TSSS Pape

Project No.	2520	Addendum No.	02
Date	27 August 2026	Pages	3
Location	1076 Pape Ave, Toronto, ON

SCALE: INDICATE	DRAWN: R.P.
DATE: MARCH/90	CHECKED:
PROJECT NO: 1-800-1	DRAWING NO: A-4

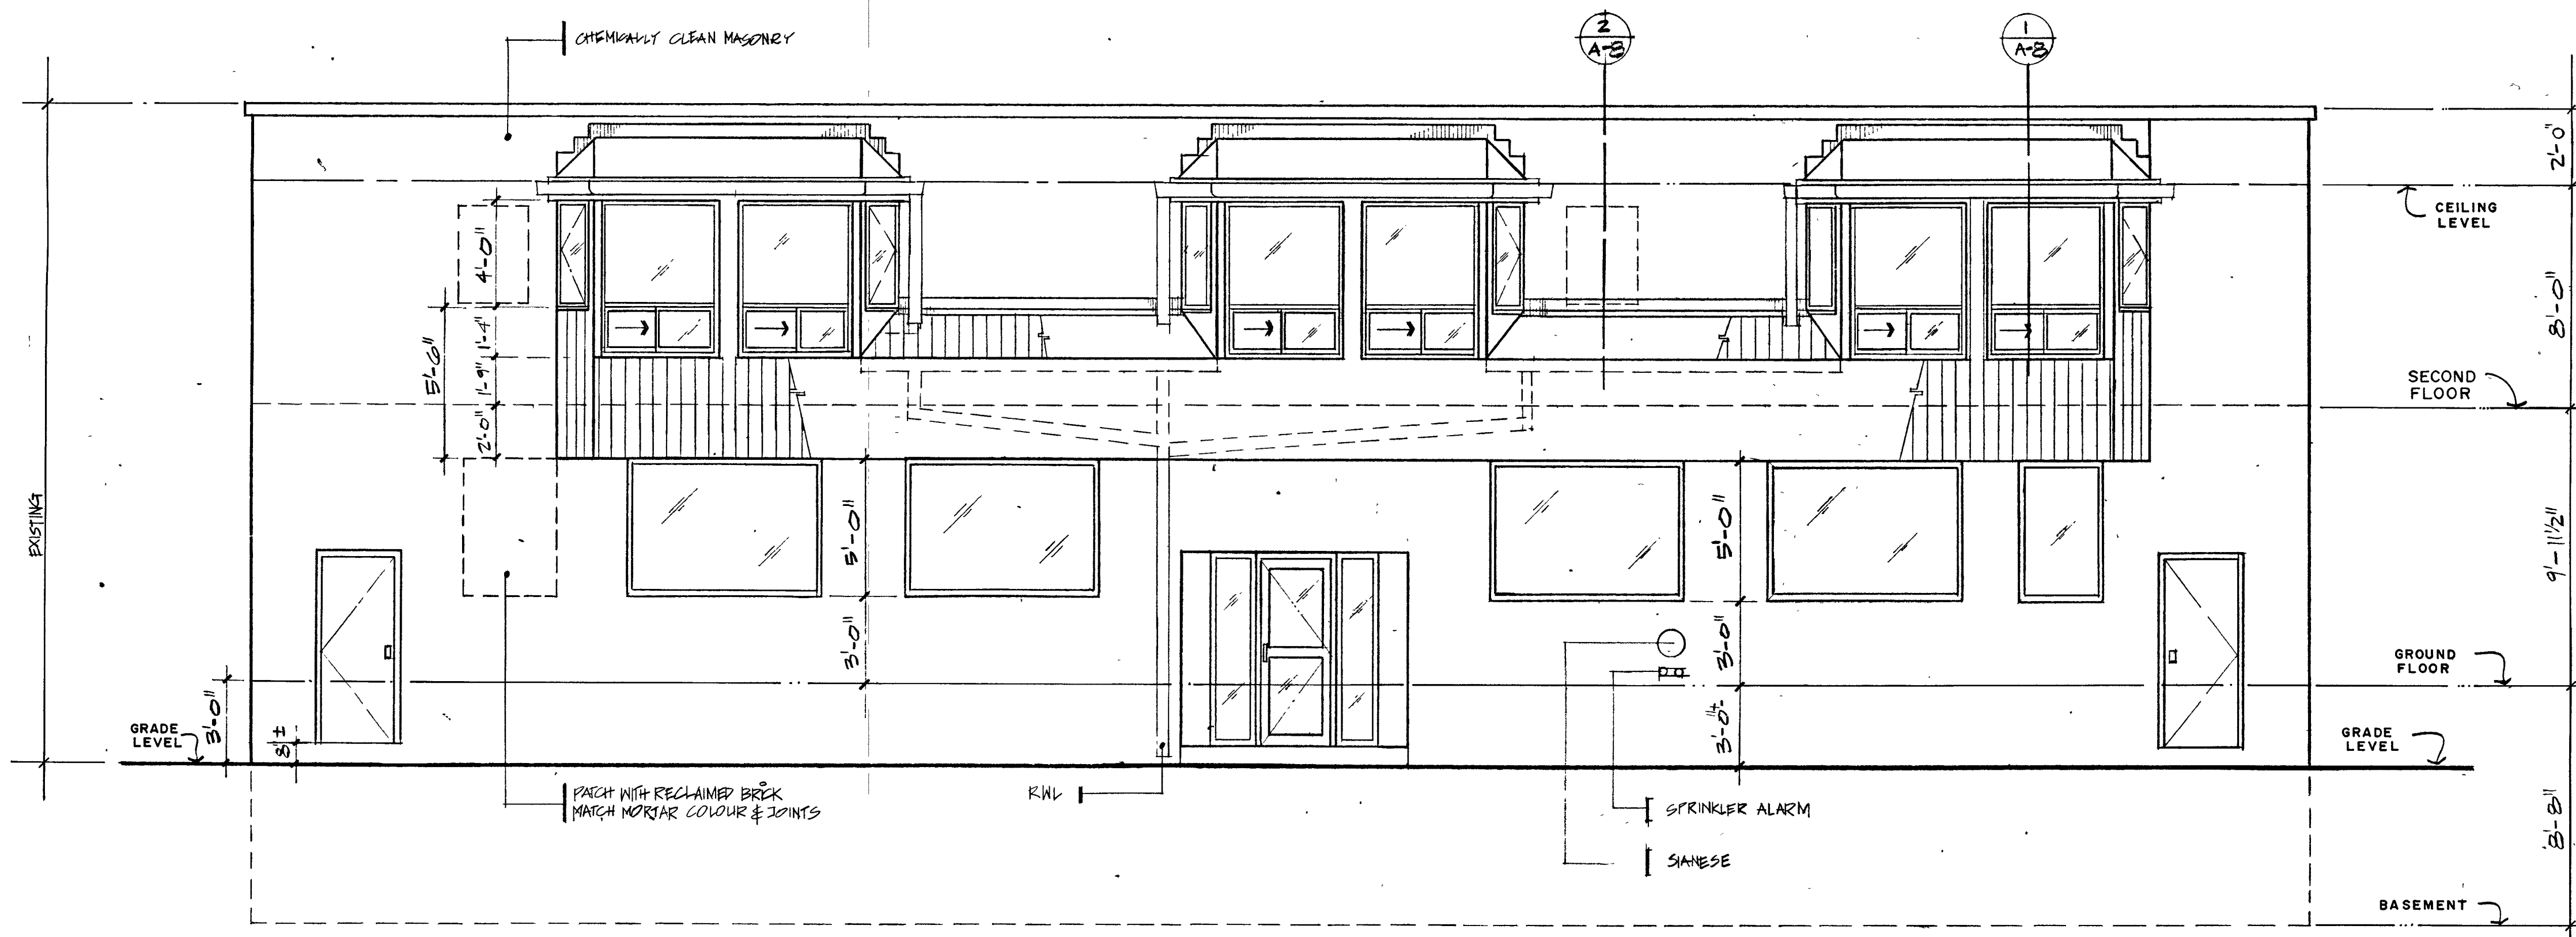
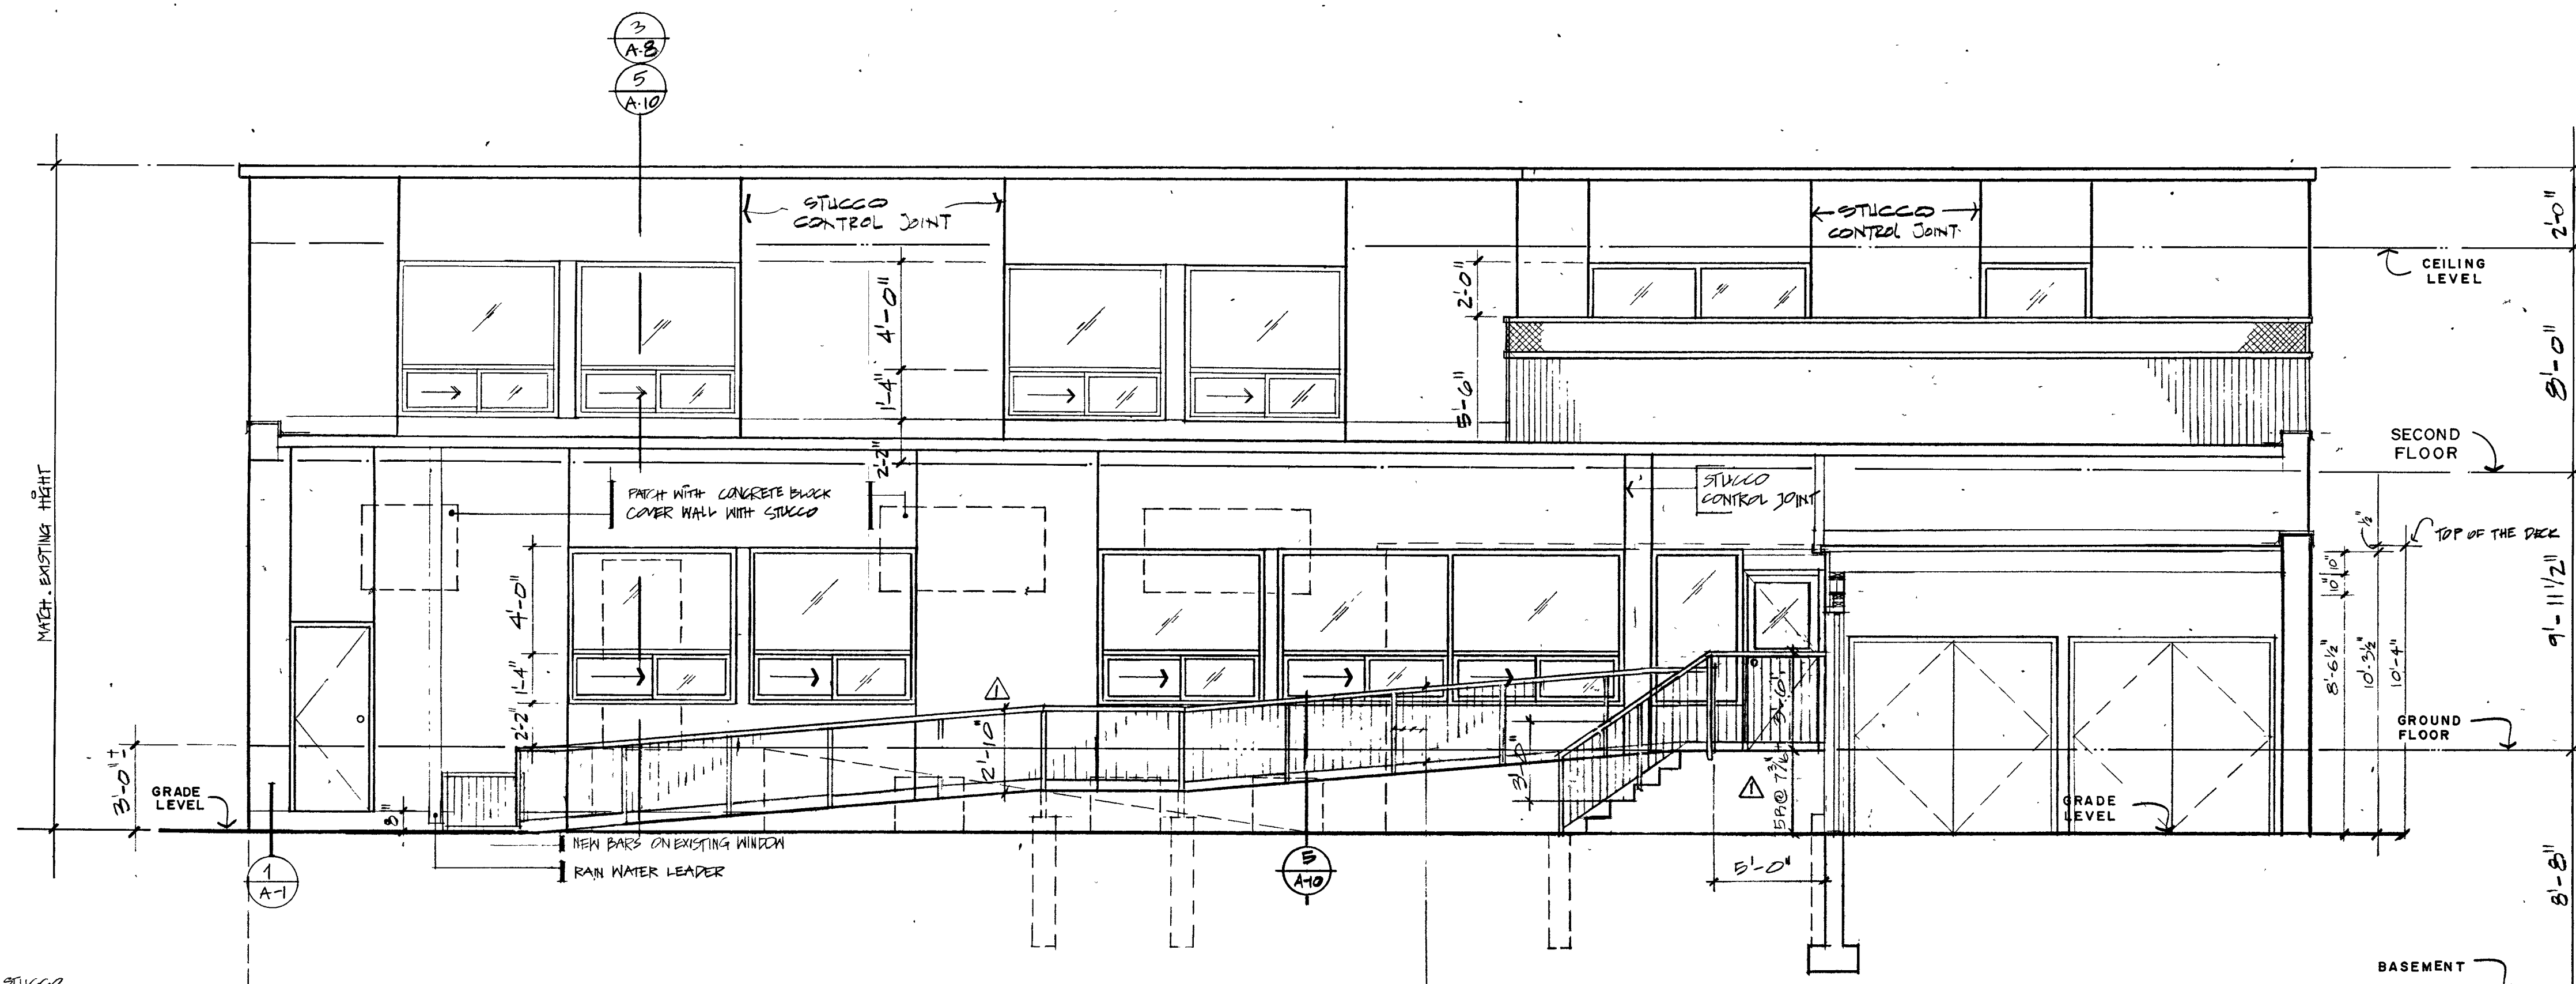
| 1. | Question: Please also provide existing roofing system composition/build-up. |

| | Answer: Please see attached existing building drawings A-4 & A-8. |
